F/CMVSS Noncompliance Recall

18136 Front Door Window Glass Temper Process Not Complete

Reference Number: N182156540

Release Date: May 2018

4595179

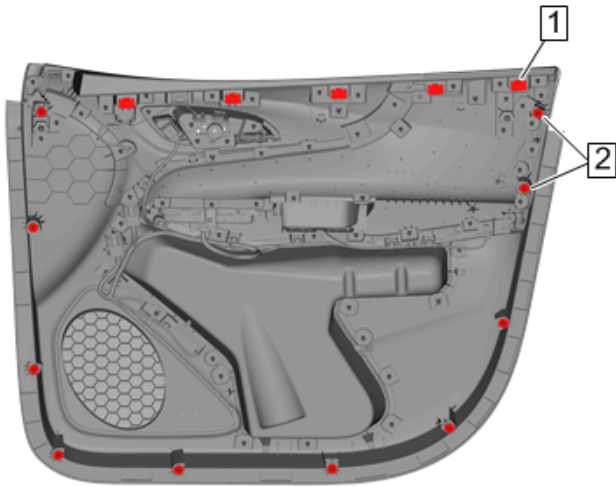
NOTE: The two rear high retention retainers (2) must be replaced when servicing the door trim. The upper retainers (1) do not require replacement.

Replace the left and right front side door windows. Refer to *Front Side Door Window Replacement* In SI.
